**TECHNICAL BULLETIN  
No. 0117****Shift Interlock for  
C20 Transmission**

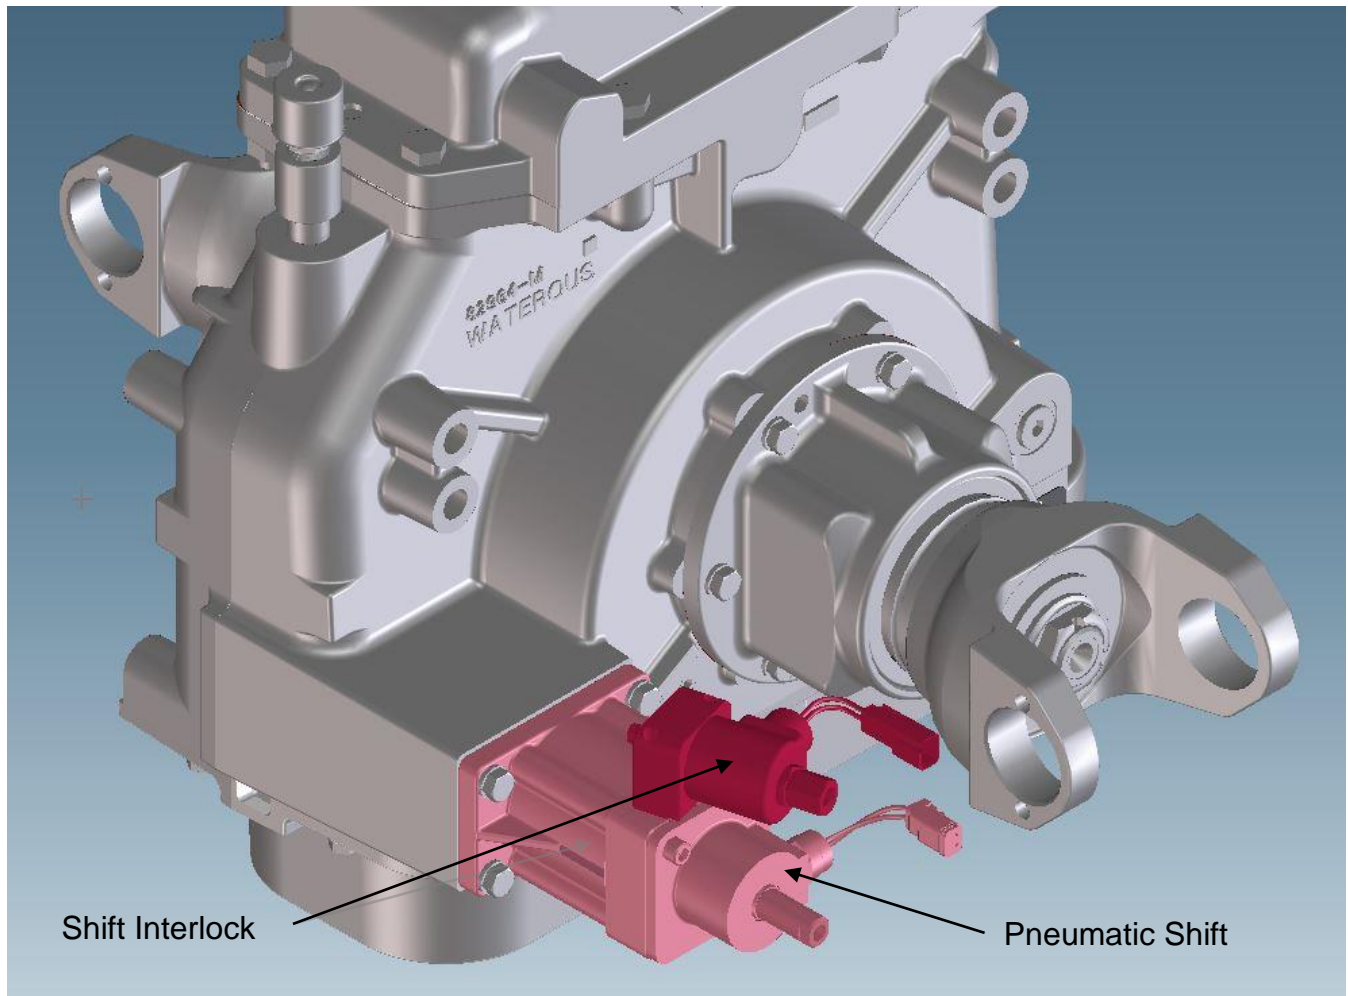
All C20 Transmissions ordered after January 1, 2016 will have the new shift interlock.

NFPA requires a shift interlock as directed by new section 16.10.1.4

*Where the pump is driven by the chassis engine and automatic transmission through a split shaft PTO, an interlock system shall be provided to prevent the pump drive system from being shifted out of the “pump engaged” pumping mode of operation when the chassis transmission is in pump gear.*

Waterous has developed an interlock system for the pneumatic shift on C20 Transmissions. This will be standard equipment on all C20 transmissions on units ordered after January 1, 2016.
